ADDENDUM NO. 02

February 19, 2025

ZHS Locker Room Addition & PVE Site Drainage
1000 Mulberry St., Zionsville, IN 46077 &
4700 S 975 E. Zionsville, IN 46077

This Addendum consists of Pages ADD 2-1 through ADD 2-3 and attached Fanning Howey Associates, Inc. Addendum No. 02, dated February 18, 2025, consisting of 2 pages and 35 drawings.

SITE PLAN

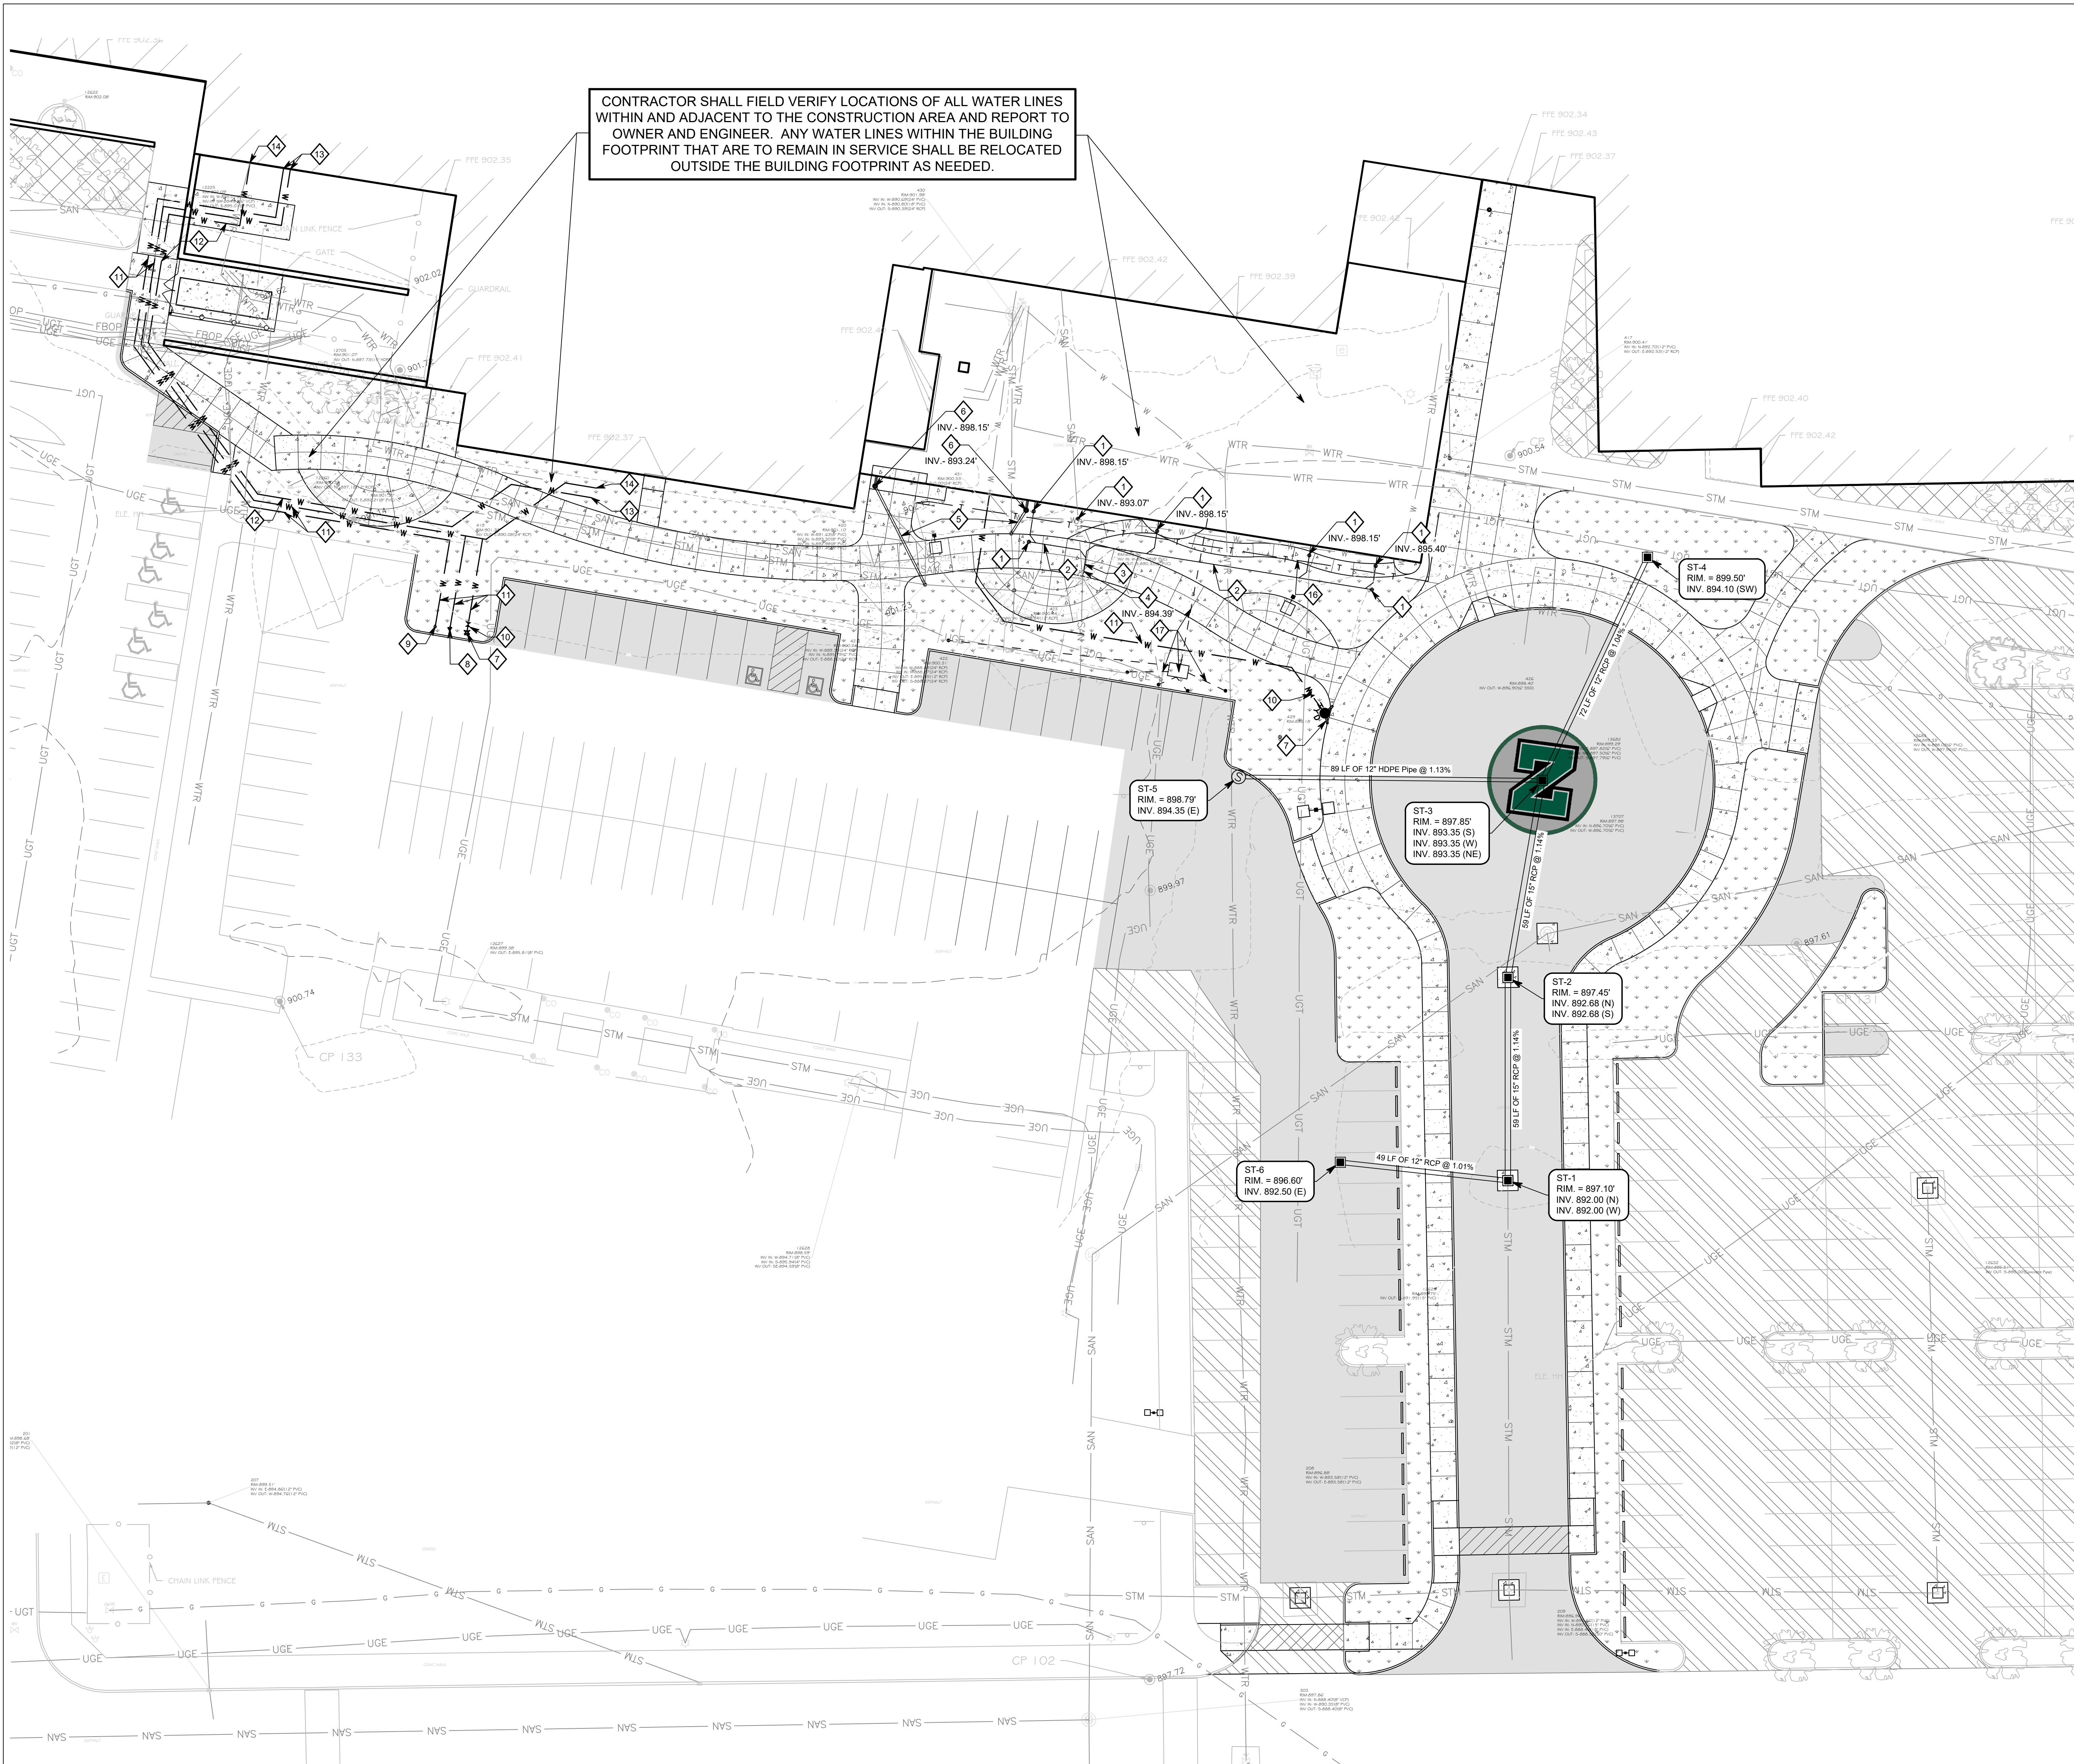
29. General Trades Contractor is responsible for providing and installing the decorative concrete bollards noted by Plan Note 23 on the Site Plan.

23. DECORATIVE CONCRETE BOLLARD - SPACED 6' ON CENTER.
